Veranda

Planned Unit Development (PUD) Amendment No. 8 (P20-223)

Planning and Zoning Board
Laura H. Dodd, AICP

P20-223 (8TH AMENDMENT)

Veranda PUD
 Amendment No. 8
 City of Port St. Lucie, Florida
 Conceptual Master Plan
 City of Port St. Lucie No. P20-
 October 4, 2020
 Date By Description

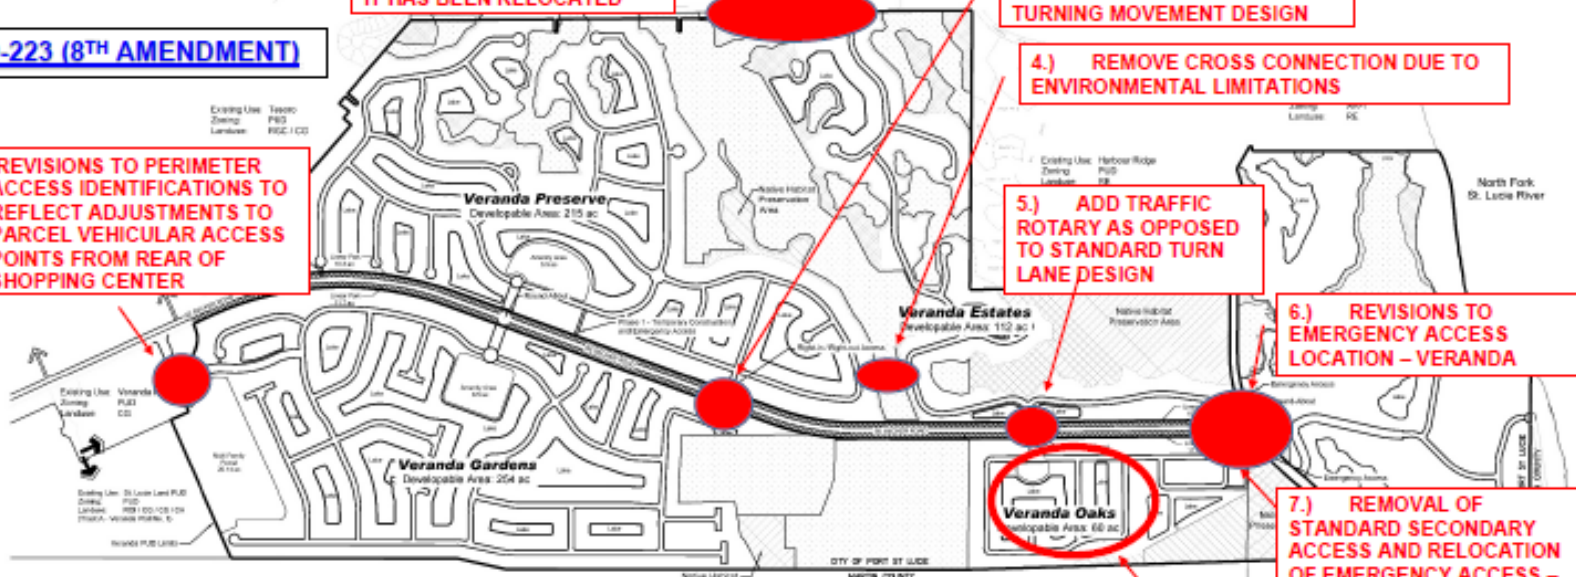
1.) REVISIONS TO PERIMETER ACCESS IDENTIFICATIONS TO REFLECT ADJUSTMENTS TO PARCEL VEHICULAR ACCESS POINTS FROM REAR OF SHOPPING CENTER

2.) REMOVE REFERENCE TO EMERGENCY ACCESS - IT HAS BEEN RELOCATED

3.) ADD TRAFFIC ROTARY AS OPPOSED TO RESTRICTED TURNING MOVEMENT DESIGN

4.) REMOVE CROSS CONNECTION DUE TO ENVIRONMENTAL LIMITATIONS

5.) ADD TRAFFIC ROTARY AS OPPOSED TO STANDARD TURN LANE DESIGN

6.) REVISIONS TO EMERGENCY ACCESS LOCATION - VERANDA

7.) REMOVAL OF STANDARD SECONDARY ACCESS AND RELOCATION OF EMERGENCY ACCESS - VERANDA OAKS

8.) UPDATED BASIC INTERNAL CIRCULATION PLAN FOR THE VERANDA OAKS AREA

9.) ADD REFERENCES TO LINEAR PARK
